# *In-vehicle battery durability e-HDVs*

## *Open Items*

Elena Paffumi, Gian-Luca Patrone  
EVE IWG 72<sup>nd</sup> , web-meeting,  
June 17<sup>th</sup>-18<sup>th</sup> , 2024

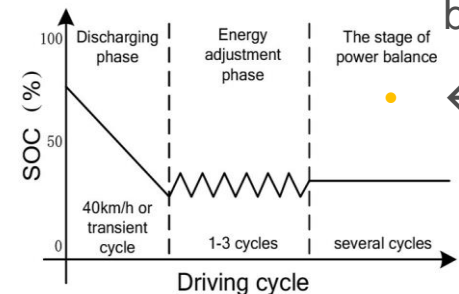
Japan: at least 1500sec ?  
 JE05 : 1830 sec  
 WLTP 4 : 1800 sec  
 WLTP 3 : 1477 sec

Japan: 4 per cent of cumulative UBE

# e-HDV's tests open questions: Break-off criterion EVE IWG 71st

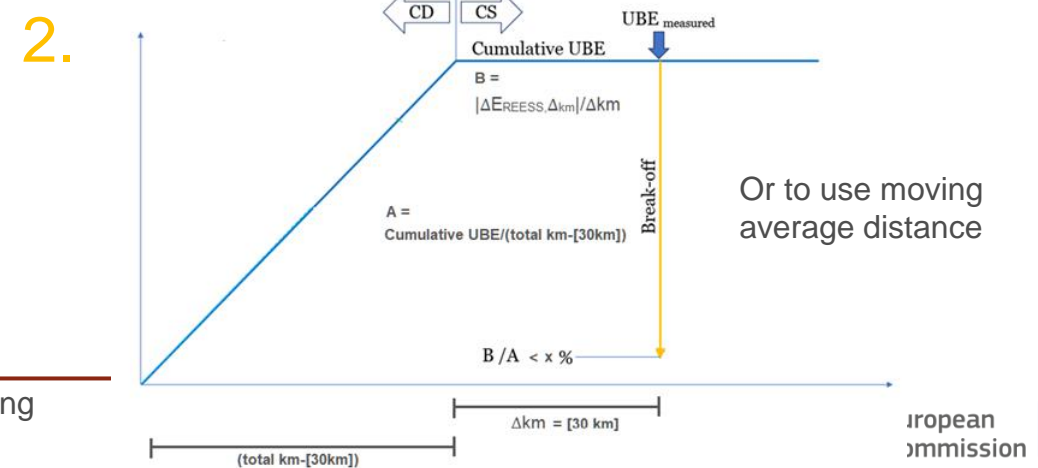
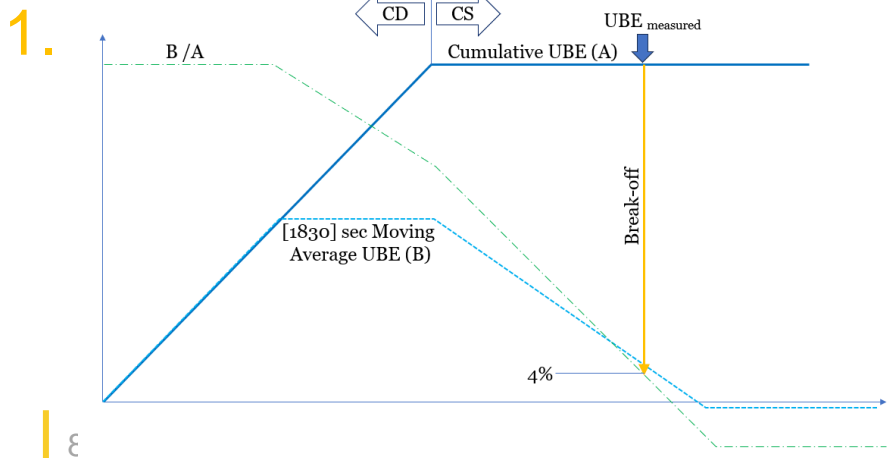
Japan: at least 1500sec ?  
JE05 : 1830 sec  
WLTP 4 : 1800 sec  
WLTP 3 : 1477 sec

Japan: 4 per cent of cumulative UBE

30 km ?

2-3-5 per cent ?

1. [the  $|\Delta E_{REESS,dt}|$  in the last xx dt of driving is equal to or less than xx per cent of the cumulative UBE. The manufacturer shall provide evidence to the responsible authority after the test that this requirement is fulfilled. ]
2. [the  $|\Delta E_{REESS,\Delta km}|/\Delta km$  in the last xx km of driving is equal to or less than xx per cent of the cumulative UBE/(total distance travelled -  $\Delta km$ ) (energy consumption before the last  $\Delta km$ ). The manufacturer shall provide evidence to the responsible authority after the test that this requirement is fulfilled. ]

# Method 1a Discharge by standard average speed on a test track

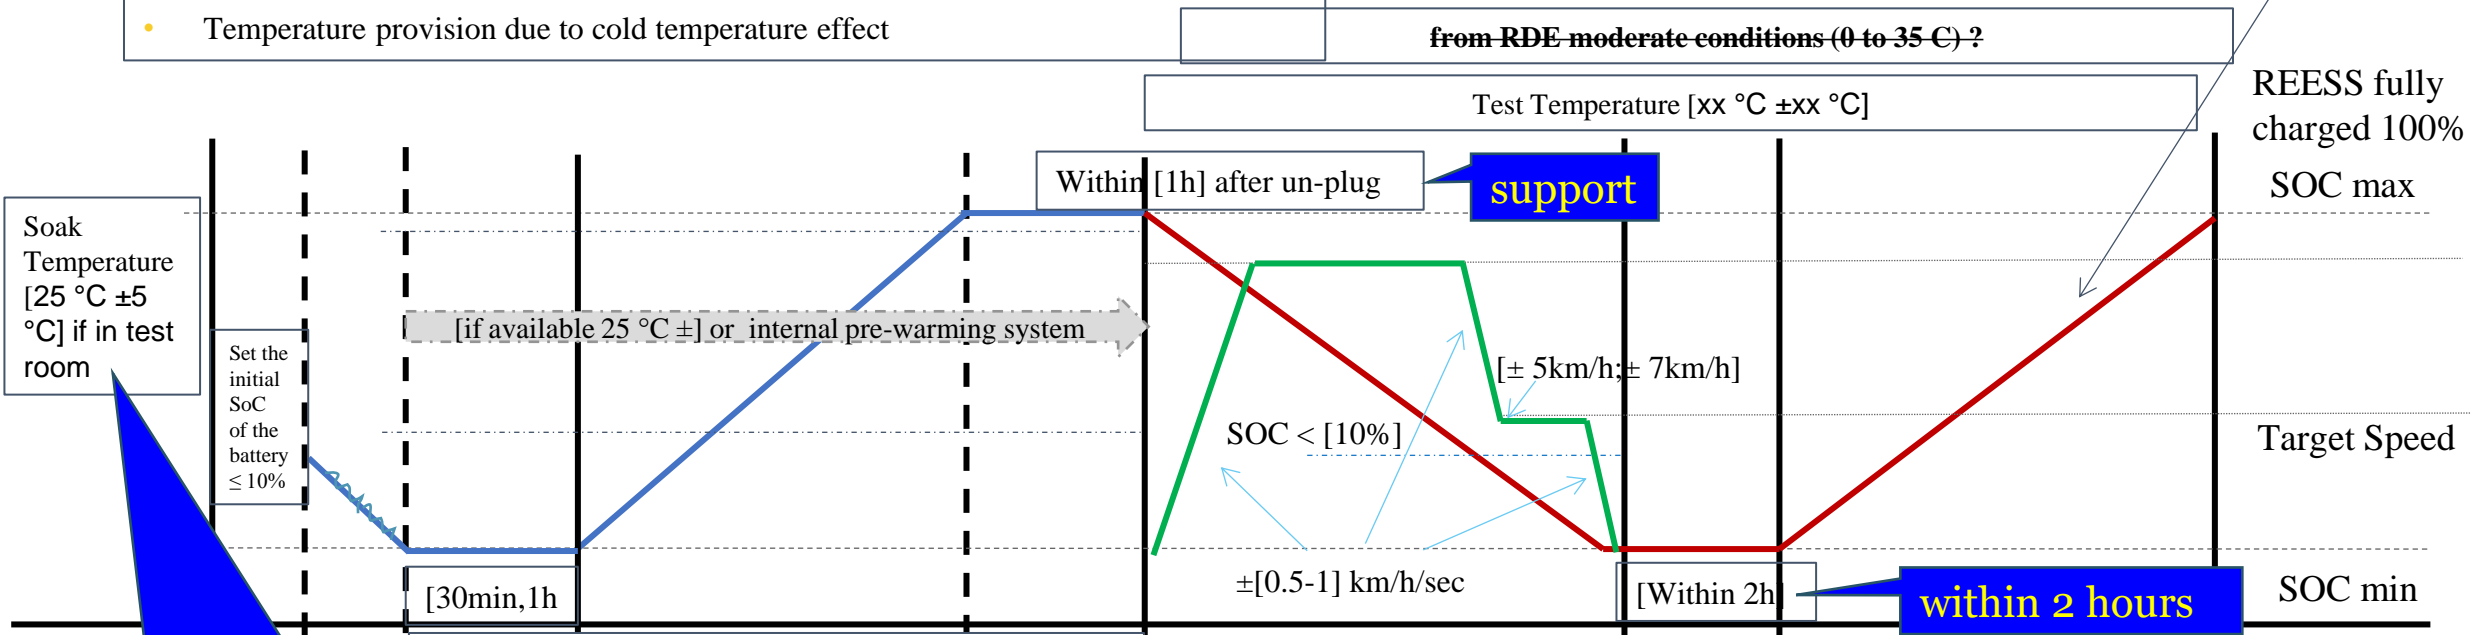
- Range of speed per category per region track
- To leave open the speed for the test and prescribe only the target speed in the last part of the test for which a speed tolerance will be applied
- The last part of the test starts when the SOC < [10%] (to be verified)
- Speed tolerance in last test segment [ $\pm 5\text{km/h}; \pm 7\text{km/h}$ ]
- The acceleration/deceleration during vehicle speed change shall be smooth and accomplished within the range  $\pm[0.5-1]$  km/h/sec
- End of discharge: break-off criterion
- Temperature provision due to cold temperature effect

from RDE moderate conditions (0 to 35 C)?

Japan:  $23 \text{ or } 25 \pm 5 = 18 \sim 30\text{ }^\circ\text{C}$  as an option, wider temperature range is acceptable without any correction if manufacture allows.

not able to support

# Method 1b Discharge by driving on the road with average speed

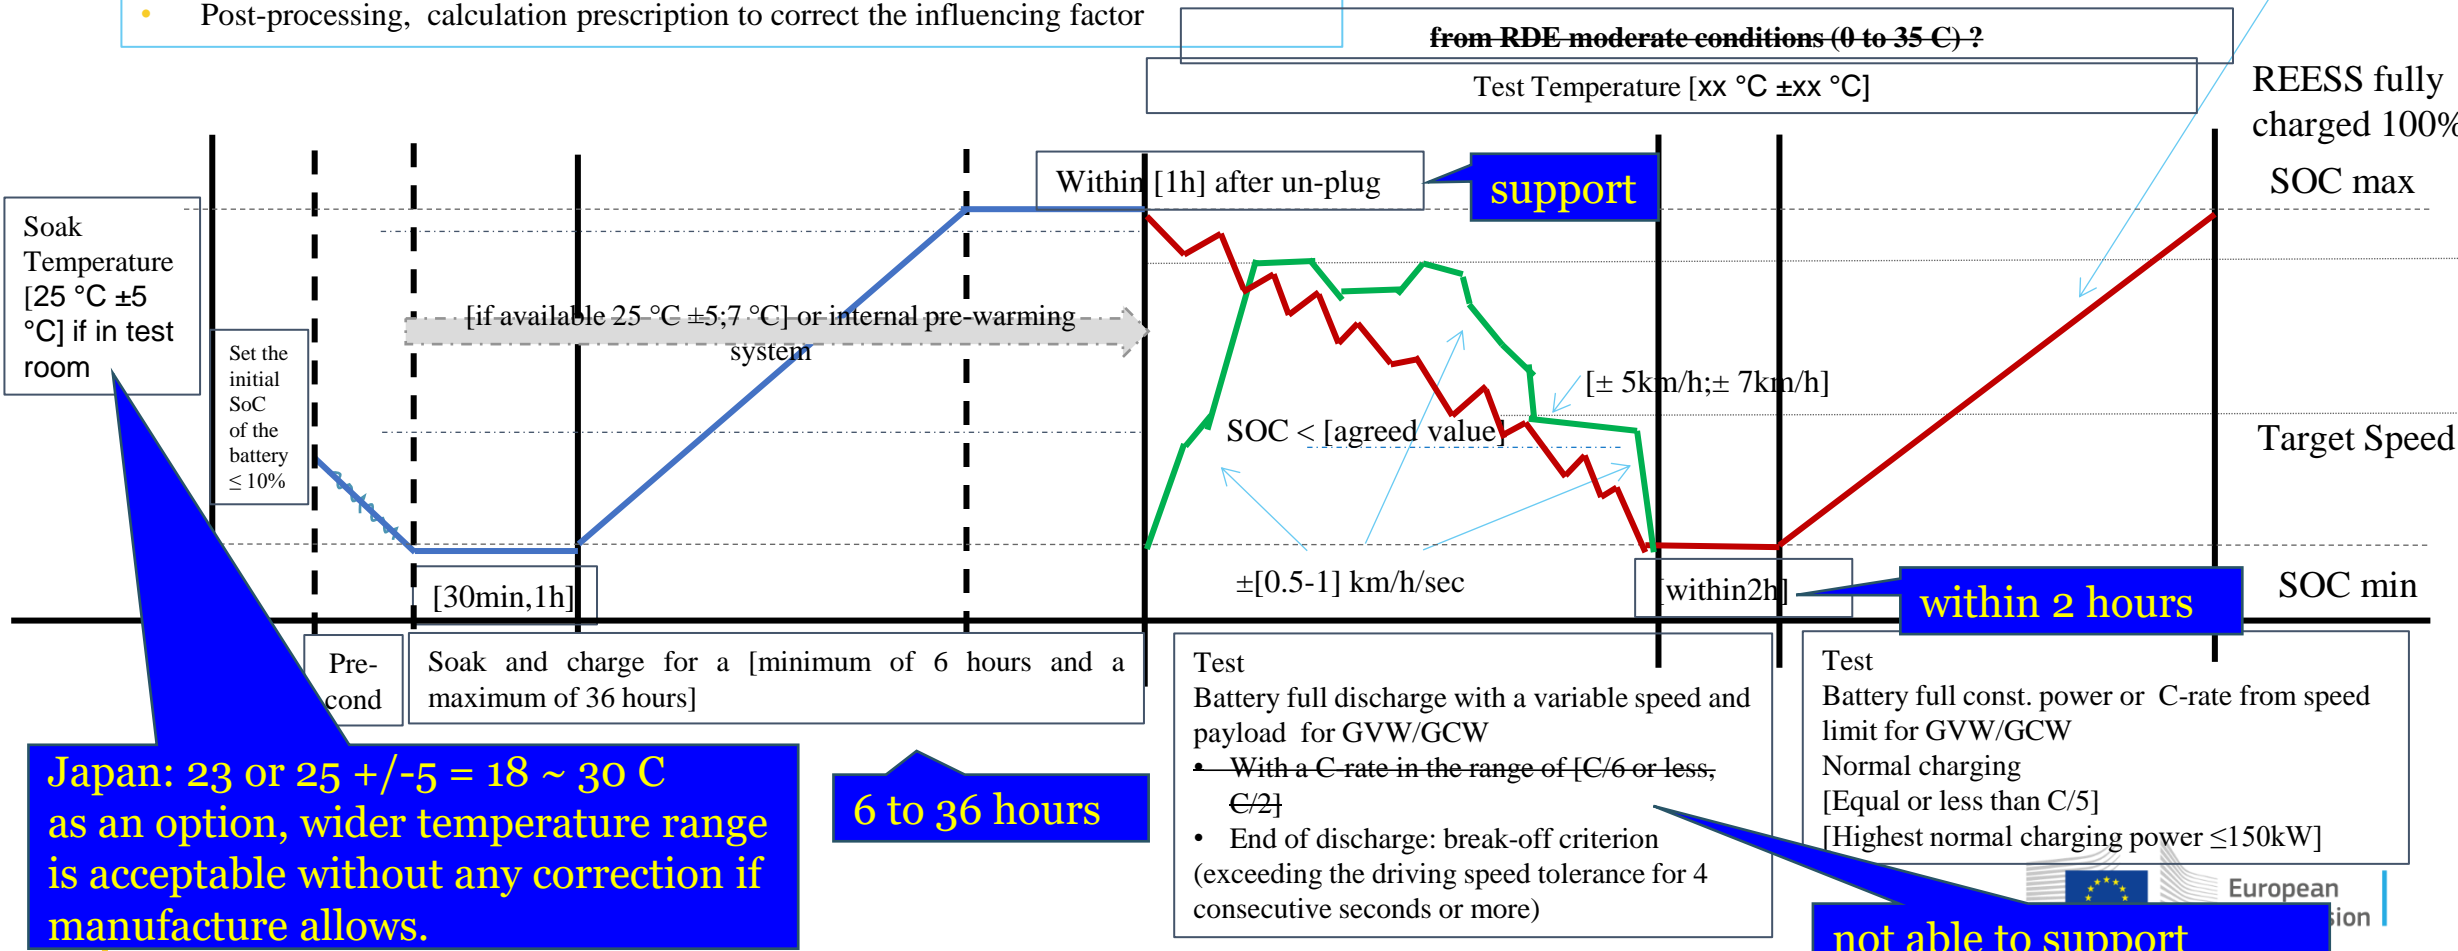
- Range of on-road speed per category per region
- To leave open the speed for the test
- The last part of the test starts with a given SOC level
- Some agreement with local regional authority for SOC minimum level and test
- Same route as type approval or different in accordance with regional authority
- If same routes is used, different provision on minimum SOC level and test
- Speed tolerance? in last test segment ?
- The acceleration/deceleration during speed change shall be as smooth as possible in relation to traffic conditions and safety of driving
- Post-processing, calculation prescription to correct the influencing factor

from RDE moderate conditions (0 to 35 °C)?

Japan: 23 or 25 +/- 5 = 18 ~ 30 C as an option, wider temperature range is acceptable without any correction if manufacture allows.

# Method 2 bidirectional charging system available

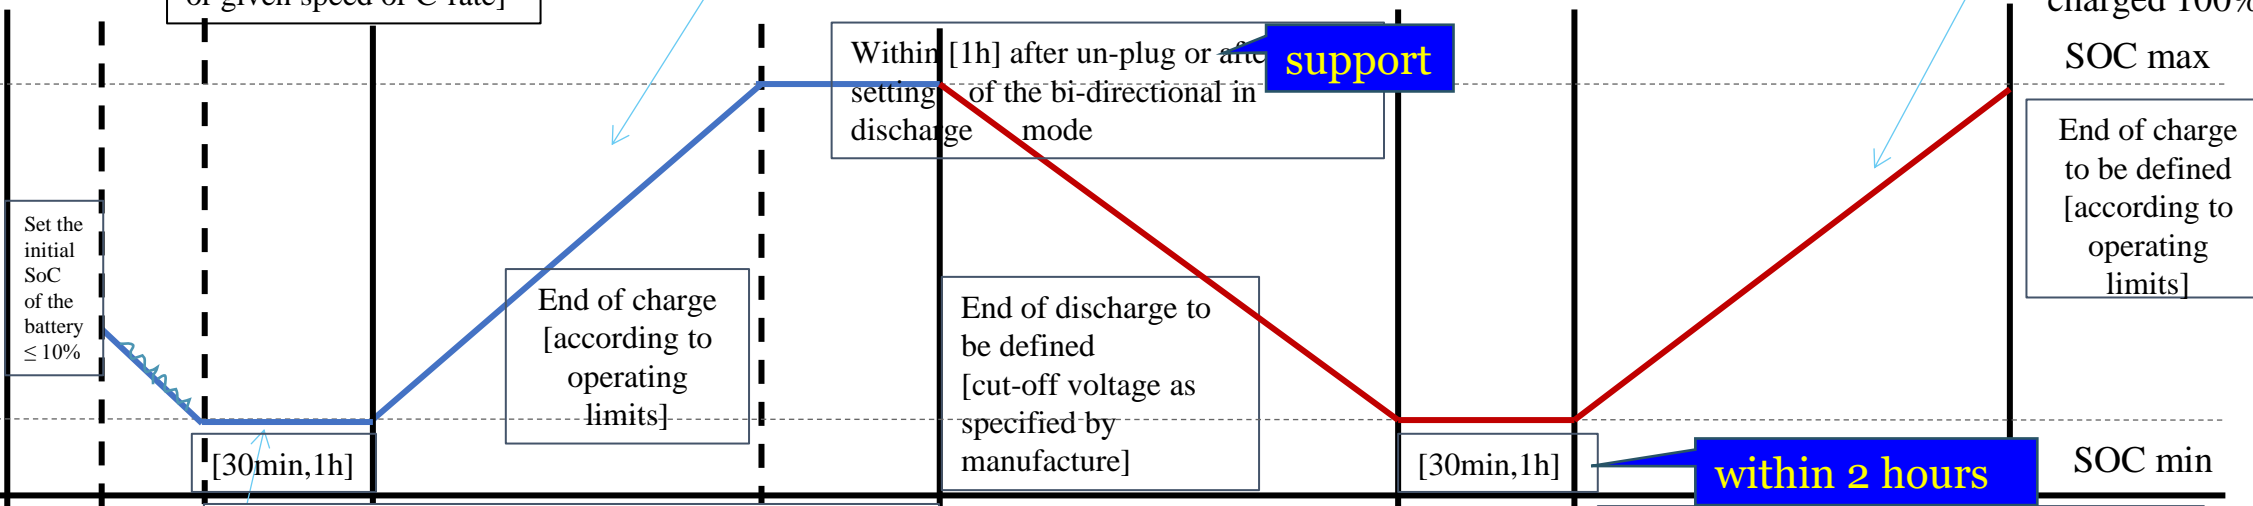
within 0 ~ 35 C

follow manufacture recommendation

not able to support

End of discharge to be defined for bi-directional charging test [Cut-off voltage]
